U.S. Department
of Transportation
**Federal Aviation
Administration**

June 8, 2022

Option B Preliminary Assessment Summary

Additional Information within the Proposal

Figure 14. Proposal and SNA Arrivals

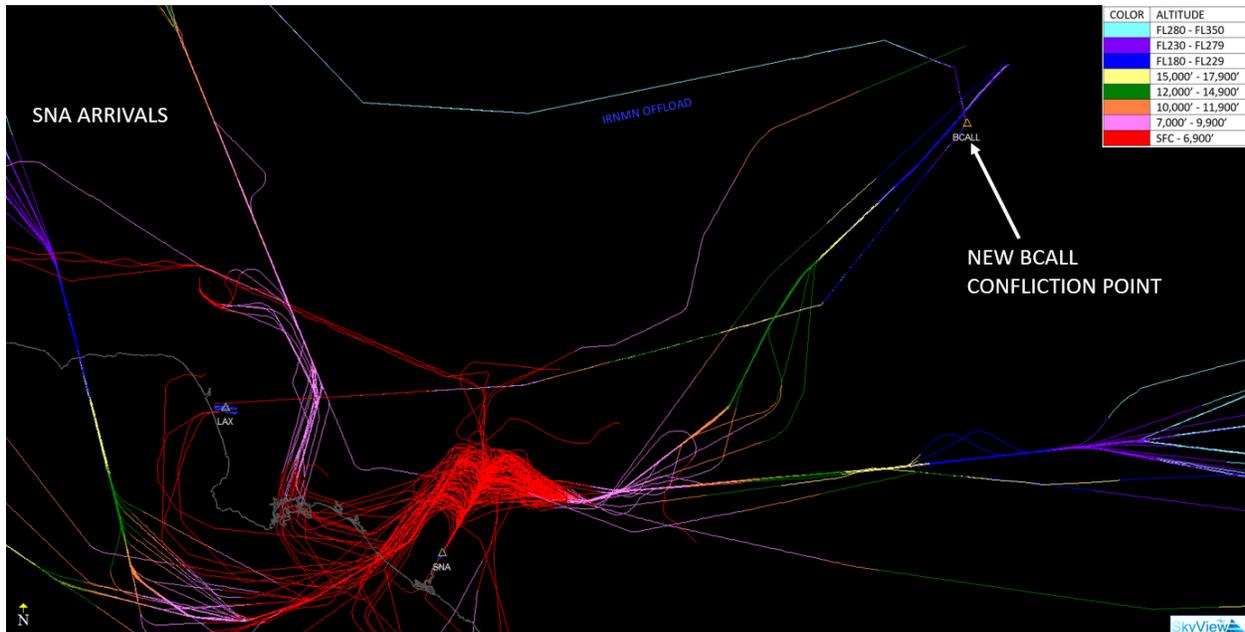
Figure 14 shows that some John Wayne/Orange County Airport (SNA) arrivals would need to descend earlier to ensure they are below the additional proposed route aircraft. LGB/BUR/SAN departures would need to be addressed, possibly by stopping LGB/BUR/SAN departure climbs at even lower altitudes or descending SNA arrivals significantly earlier to ensure they stay below the departure path.

Figure 15. Proposal and SNA Departures

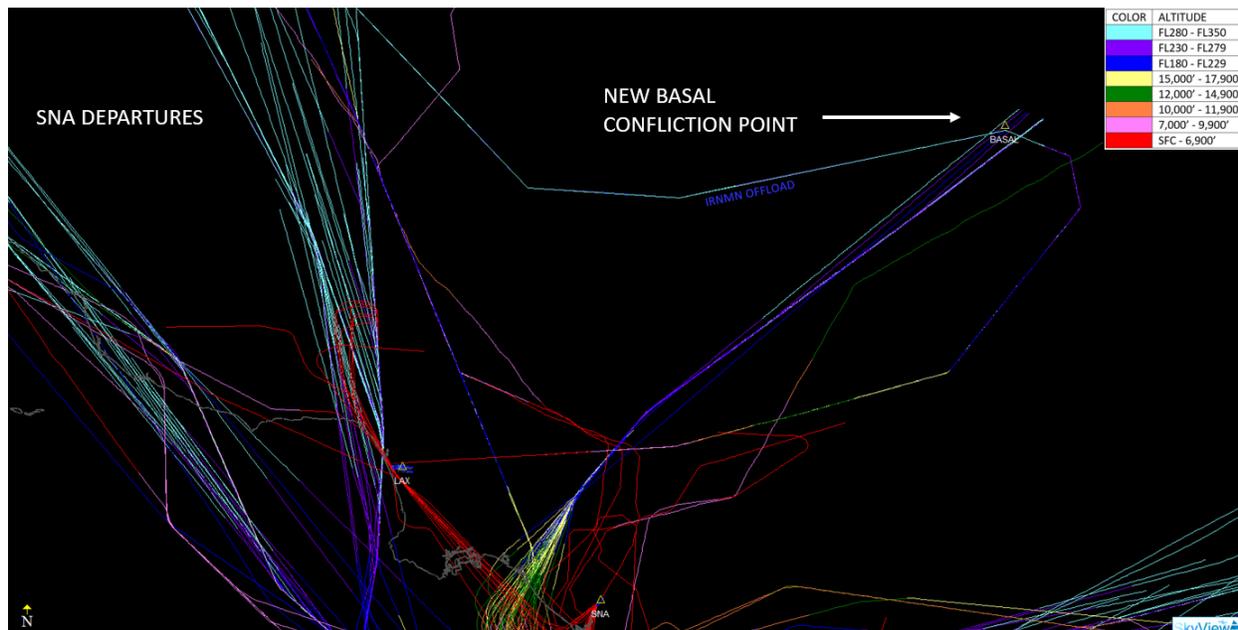
Figure 15 shows that SNA departure climbs would need to be stopped at lower altitudes, below the proposed route altitudes. LGA/BUR/SNA/SAN departures would need to be evaluated with the new inbound descending aircraft to optimize the movement of arriving and departing aircraft. Possible considerations—such as assigning departure restrictions to allow departure aircraft to climb above the inbound traffic, descending arriving traffic early, or leveling off of departure aircraft at all or some airports below the arriving aircraft—would need to be studied prior to the implementation of the Proposal.

Figure 16. Proposal and VNY Departures

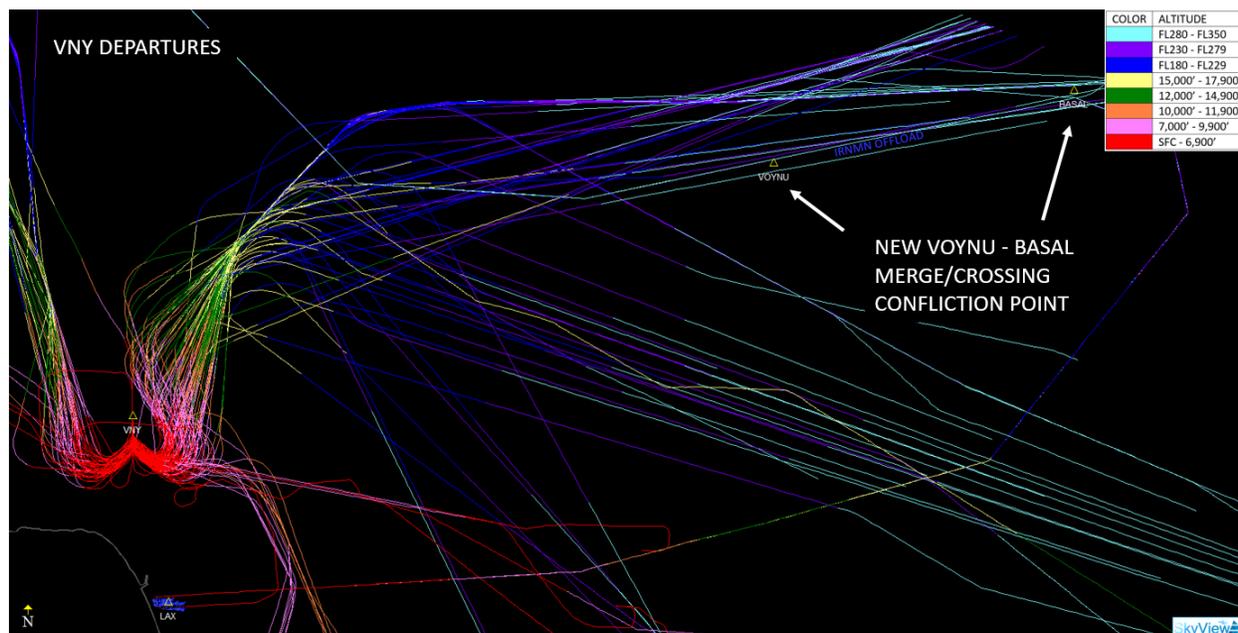
Figure 16 shows that Van Nuys Airport (VNY) departures would need to be stopped below the proposed route aircraft at similar altitudes as LGB/BUR/SNA/SAN departures. VNY arrivals would not conflict with the proposed route aircraft, but LGB/BUR/SNA/SAN departures being stopped at lower altitudes could impact VNY arrivals.

Figure 17. Proposal and SUA Expansion

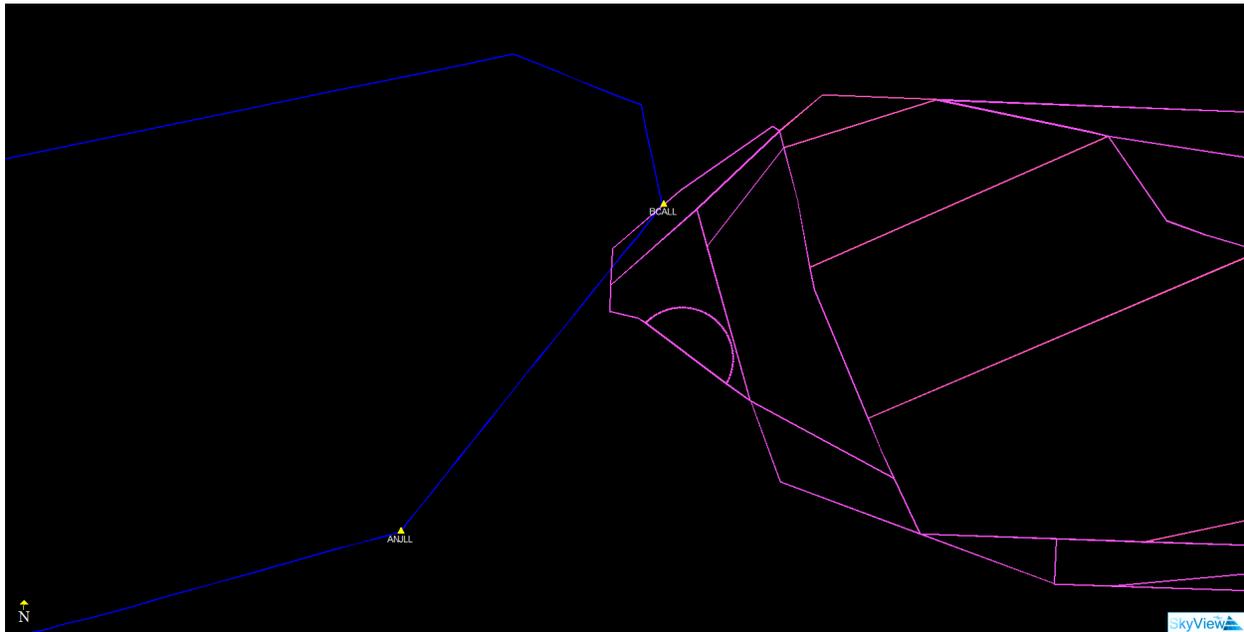
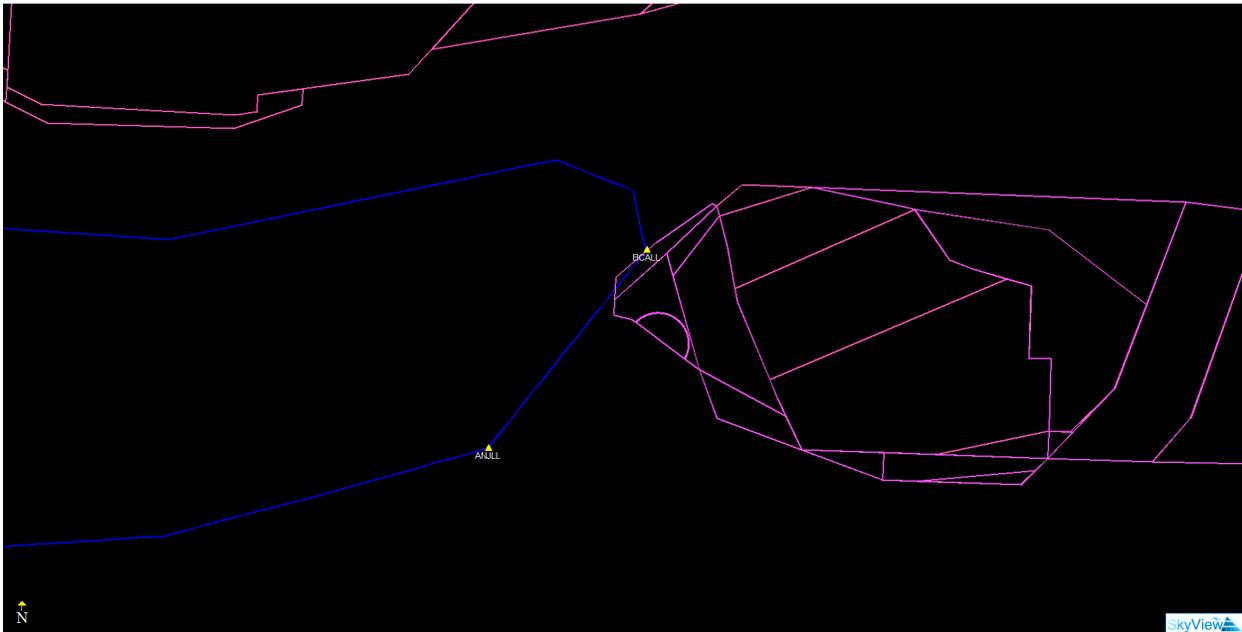
Figure 17 is a close-up graphic of the proposed route (blue) with the SUA expansion (magenta), followed by Figure 18, a zoomed-out graphic. If the expansion is approved, the new ANJLL route would need to be moved west of the SUA before turning southeast to join the arrival route.

Figure 19. Proposal Route Based on Option B Information

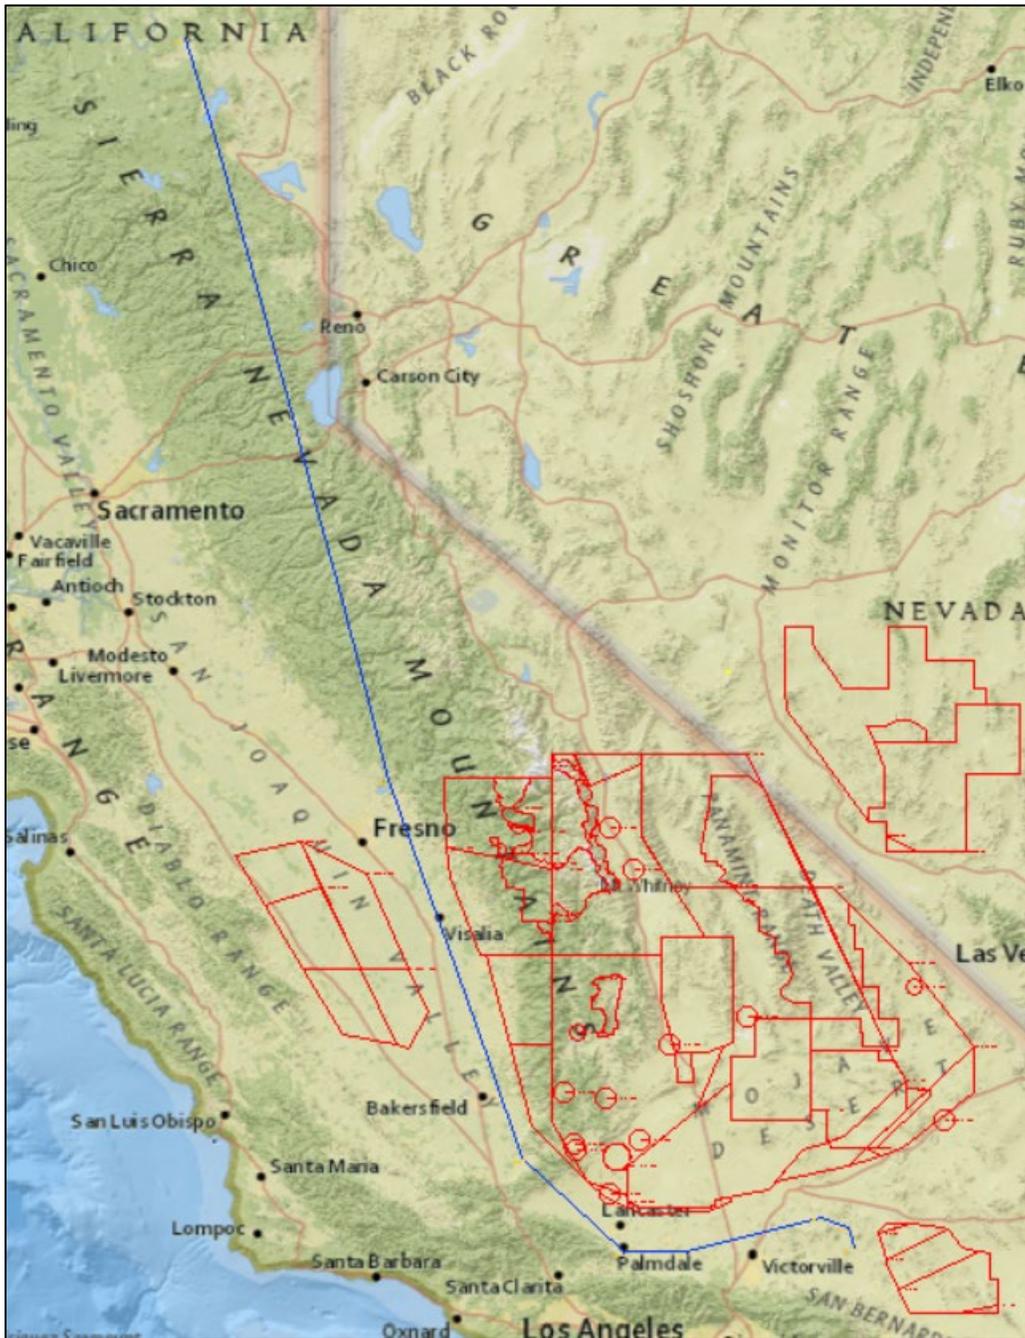
From examining the graphics within the Proposal (see Figure 1), it appears that the Proposal had no particular routing of aircraft other than a direct line drawn to a point west of the Edwards AFB R-2508 Complex and east of the current path. There was no description of how this new routing would join the current ANJLL STAR. We utilized the graphic provided by the Roundtable and made our best conjecture, shown in Figure 19, as to how this route relocation could potentially be realized. To effectively assess the data within the Proposal, we broke the route into segments, as we found it easier to evaluate when presented in this way.

The Proposal addresses the extra miles flown (an average addition of 74 flying miles to current routes). However, the Proposal does not mention any effort to obtain airline engagement or support; it appears that the potentially impacted airlines may be unaware of the increased flying miles and resulting carbon emissions. Alaska Airlines, in particular, would be disproportionately impacted, as it serves many of the routes that would be redirected.

Figure 20. Current Arrival Distribution with Altitudes

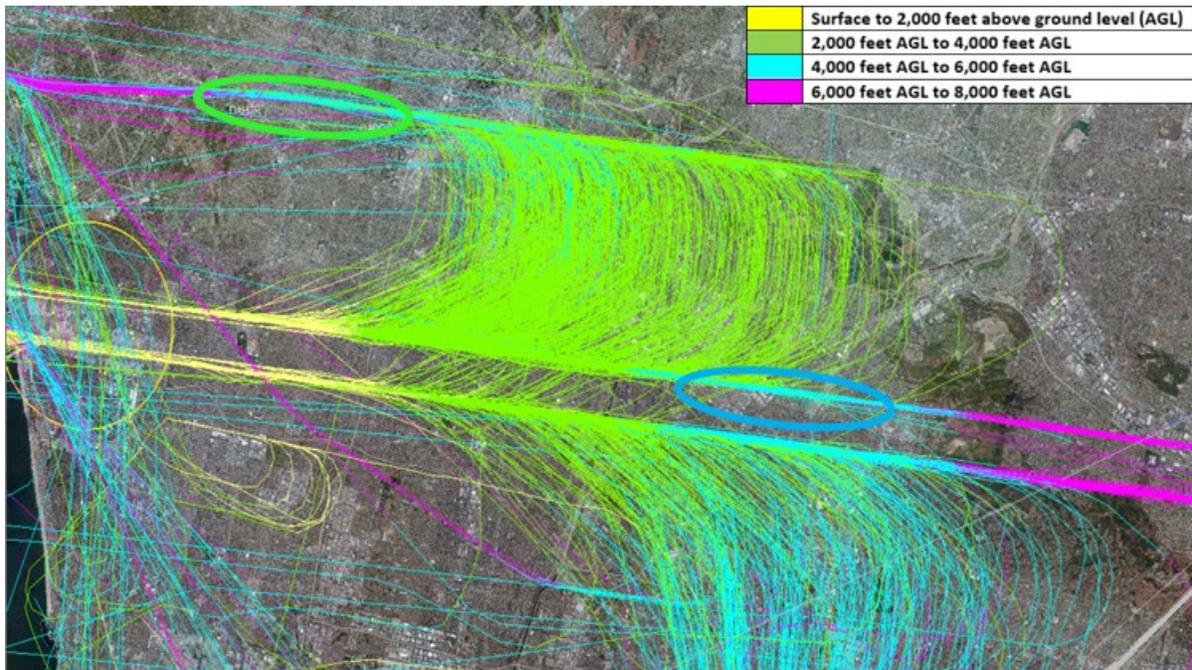
Lastly, the Proposal would redirect aircraft over communities already overflowed by aircraft from numerous airports in the area, including LAX. As shown in Figure 20, dispersion currently exists, with aircraft turning base leg from the LAX north downwind at different locations. Two areas of equal aircraft altitude are circled in green and blue. Approximately 30% of aircraft within the green circled area (DAHJR to GADDO) would be moved to the blue circled area.
